Re: Freeport-McMoRan Chino Mines Company- Updated Closure/Closeout Plan Continental Mine and Hanover Mountain Mines, Permit No. GR002RE, Response to Agencies' Comments and Request for Additional Information

Freeport-McMoRan Chino Mines Company (Chino) submitted an application to renew the Continental Mine Closure/Closeout Plan (CCP), Permit GR002RE on July 31, 2023. On November 6, 2023, Mining and Minerals Division (MMD) determined the application to be administratively complete. On November 20, 2023, an interagency inspection of Continental and Hanover Mountain Mines was conducted. In a letter dated February 19, 2024, Mining and Minerals Division (MMD) requested supplemental information and submitted a combined agency review comments and Request for Additional Information (RAI) from the following state agencies: New Mexico Mining and Minerals Division (MMD), the New Mexico Environment Department (NMED), the New Mexico Department of Game and Fish (NMDGF), and the New Mexico Department of Cultural Affairs - Historic Preservation Division (NMDCA/HPD), and the New Mexico State Forestry Division (NMSFD).

CLOSURE PLAN - SWRDF EAST - PLAN

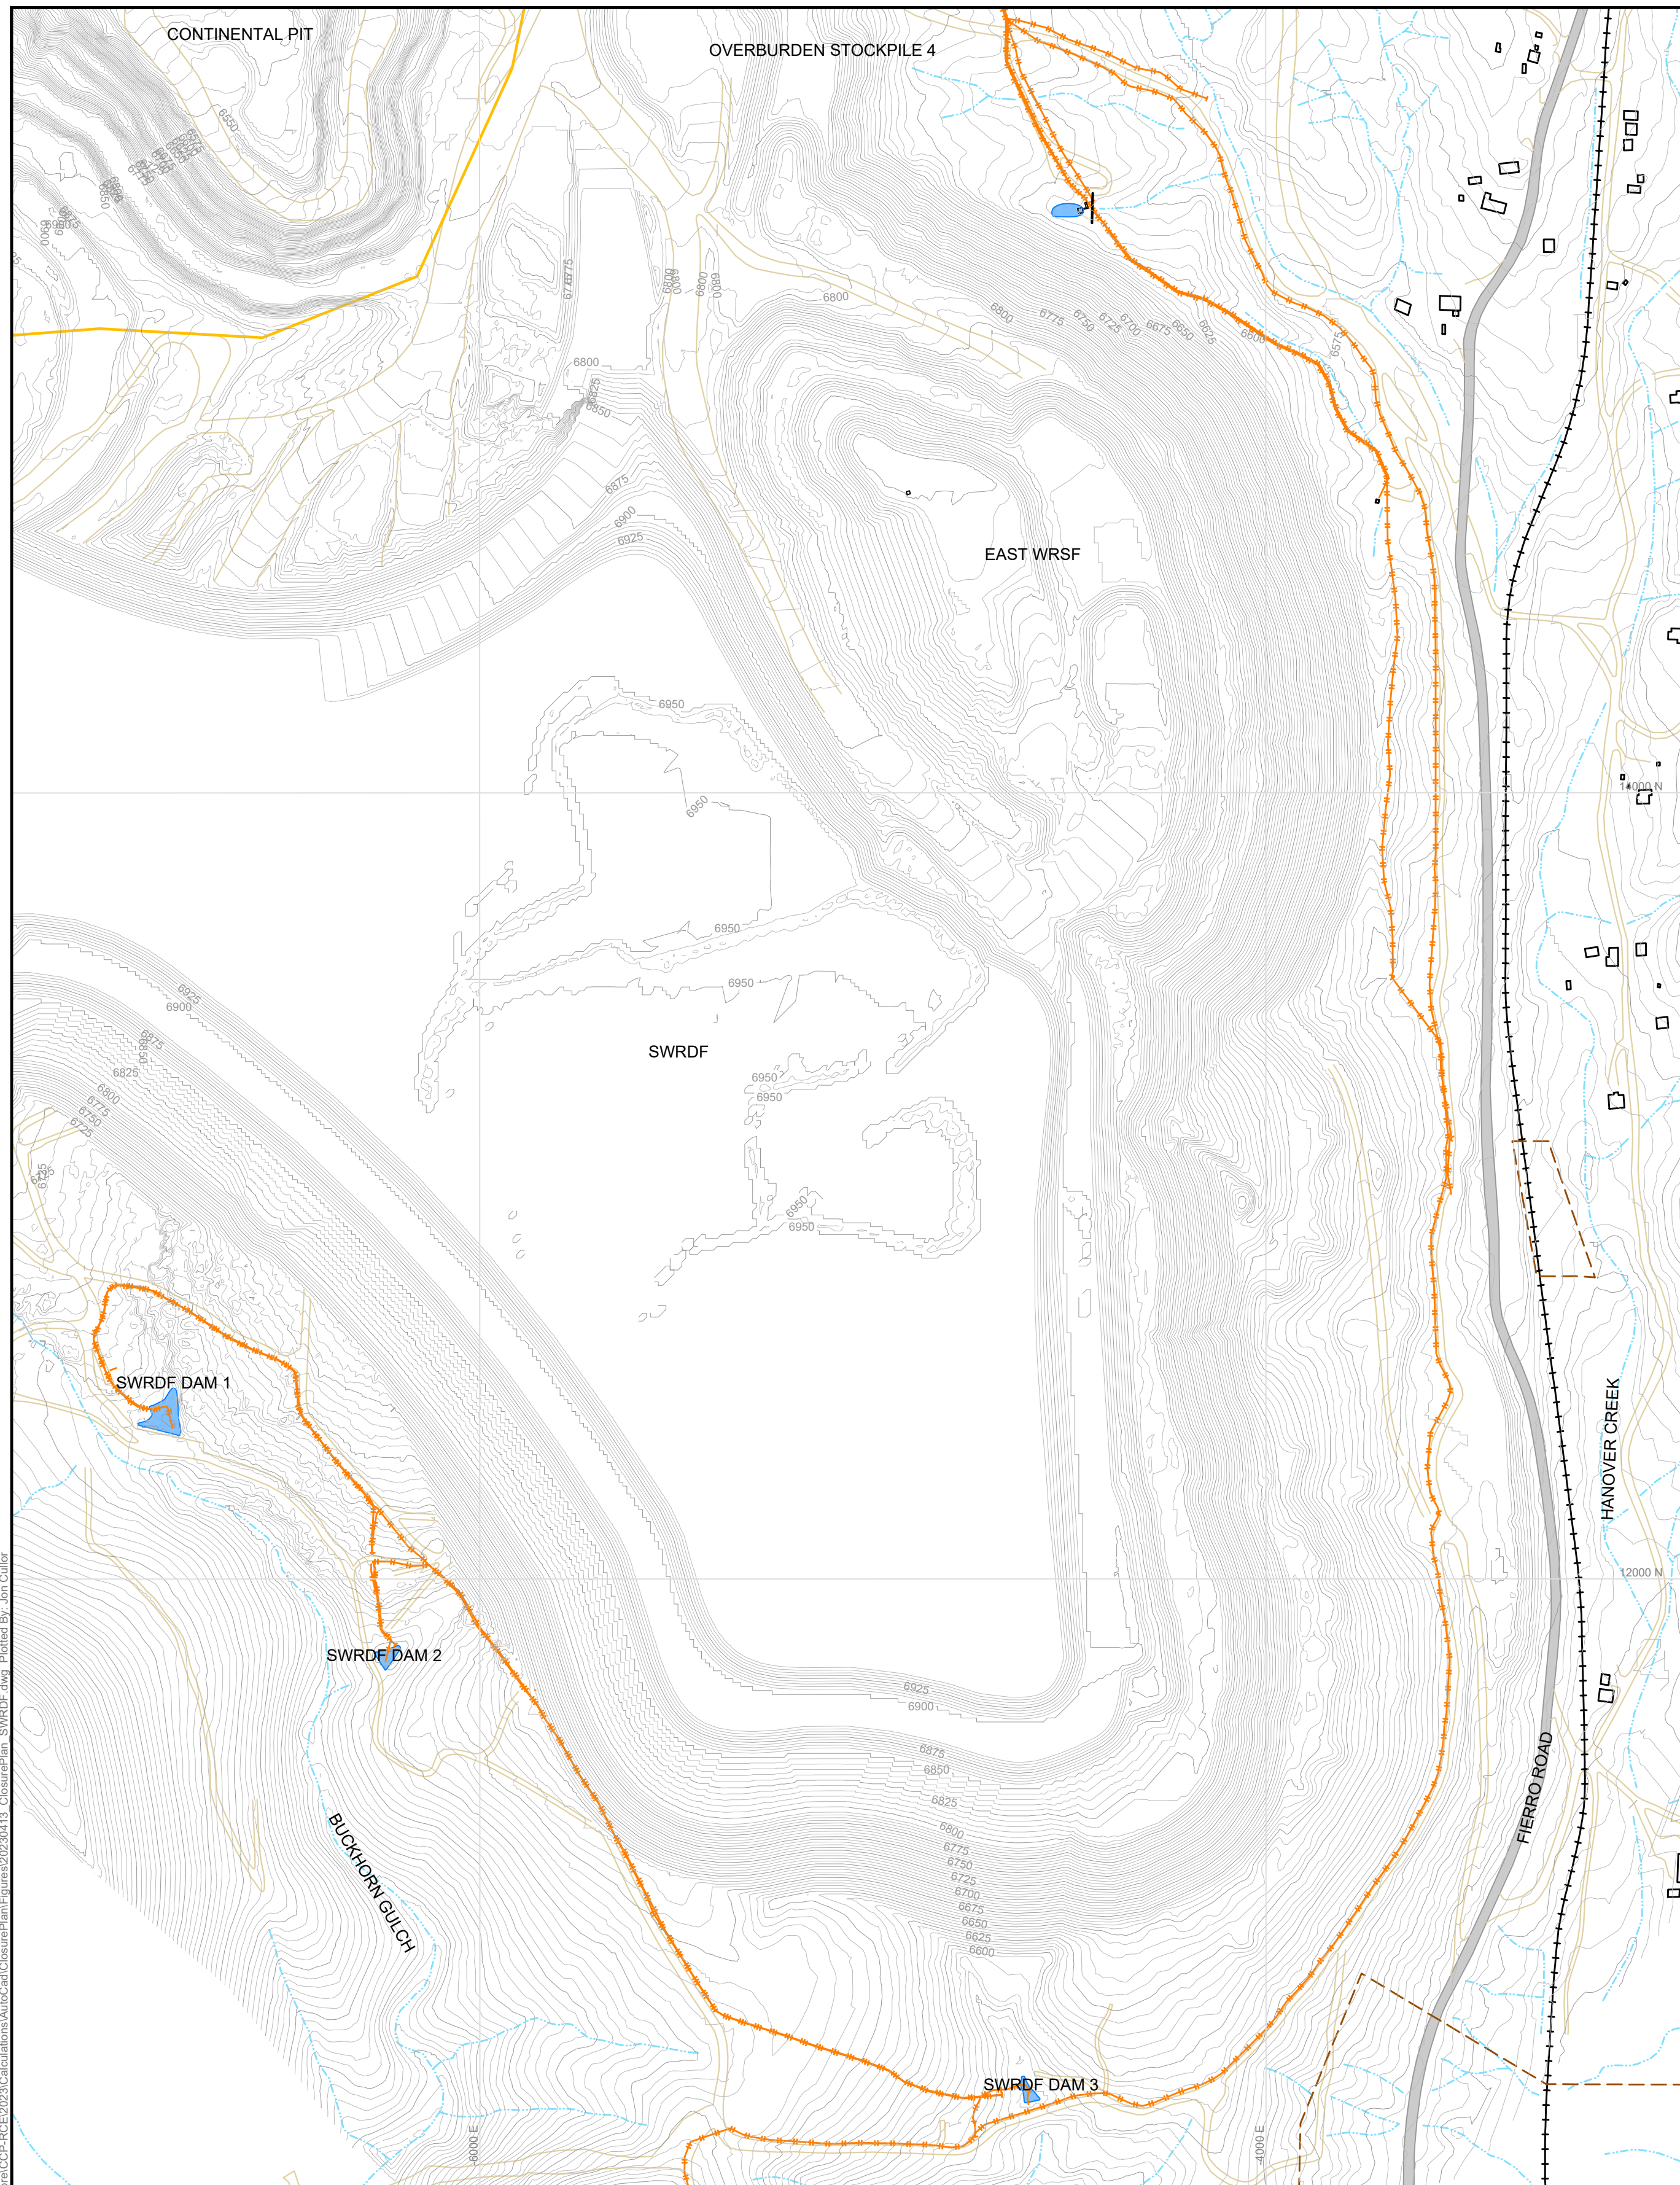
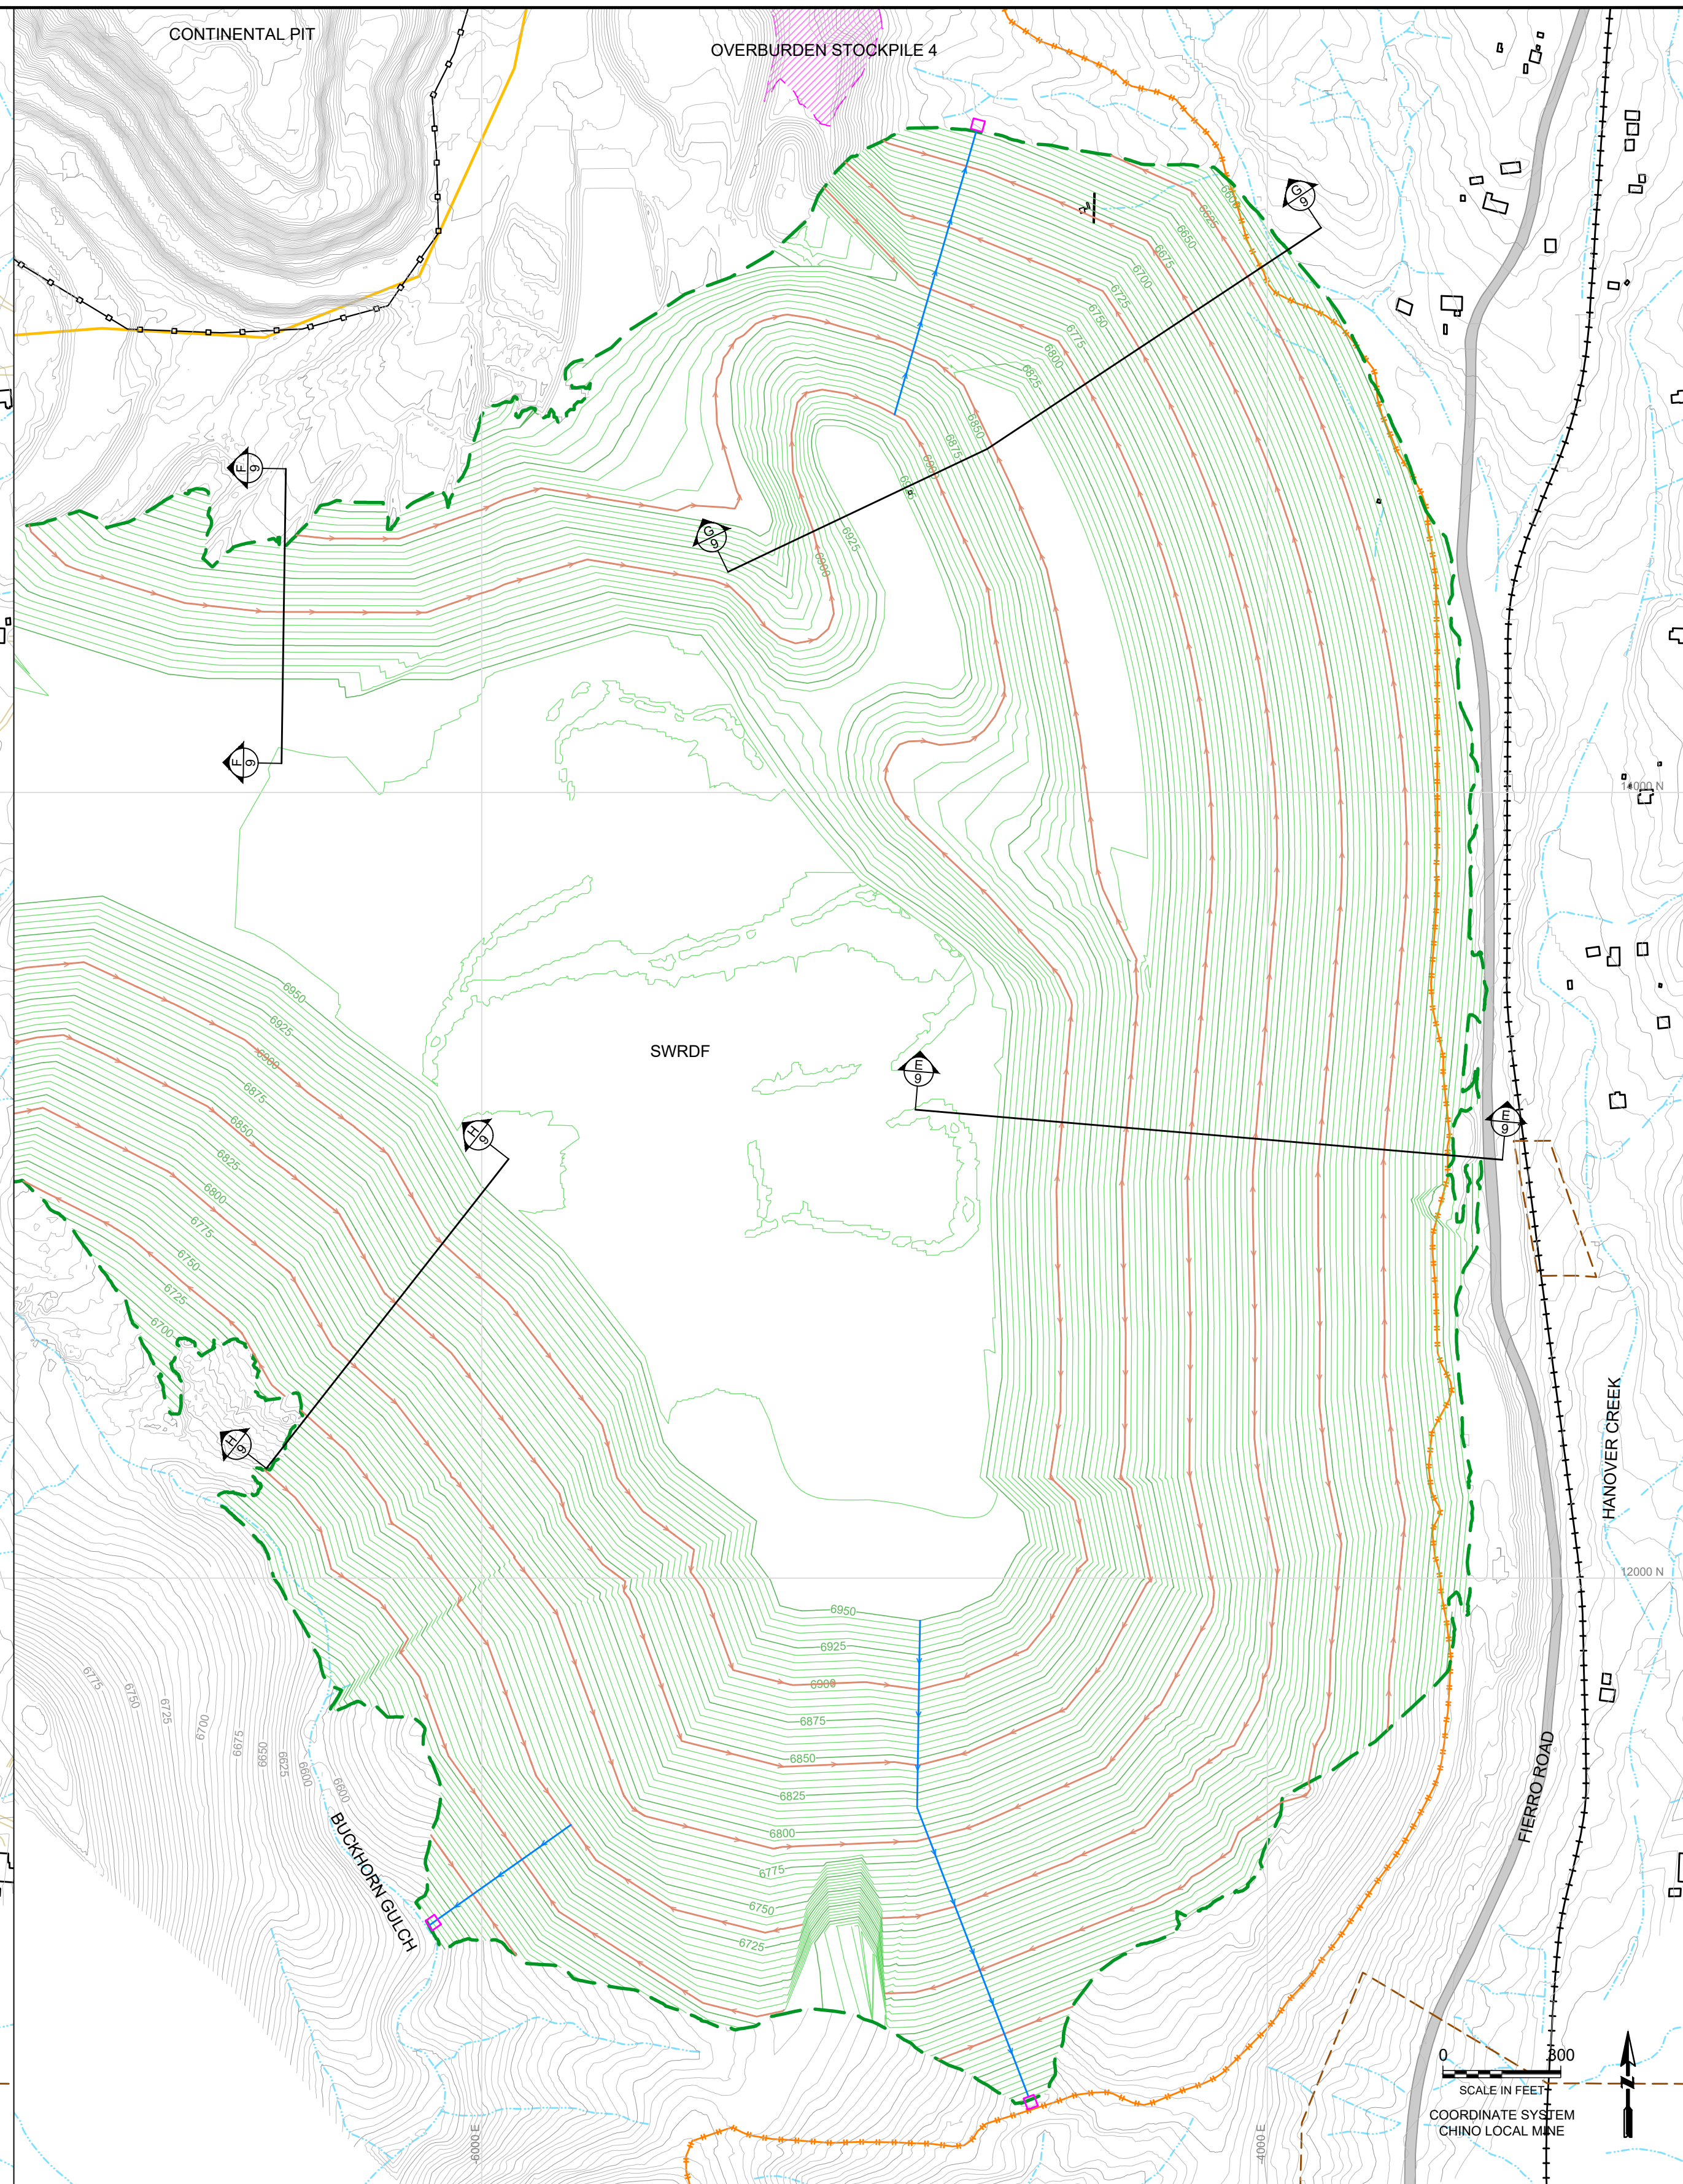
28. *Appendix E, Sheet 3 and Sheet 8. Pushdown of SWRDF crosses Fierro Road. Clarify if the pushdown will cover parts of Fierro Road, and if so, will the segment of the road be re-built.*

29. *Appendix E, Sheet 8. Plan shows converging flow at southwest end of section G. One area flows northwest and another southeast with a slope length than may be over 300 feet. Another area at southern part of the SWRDF reclamation sheet appears to have steep drop offs west of SWRDF Dam 3. Provide explanation if these areas need additional design features prior to final drawings for construction. RE: Agency Comments, Continental Mine Updated CCP, Revision 23-1, Permit No. GR002RE February 19, 2024 Page 5 of 6*

Chino appreciates this correction. Please see updated sheets 8 and 9.
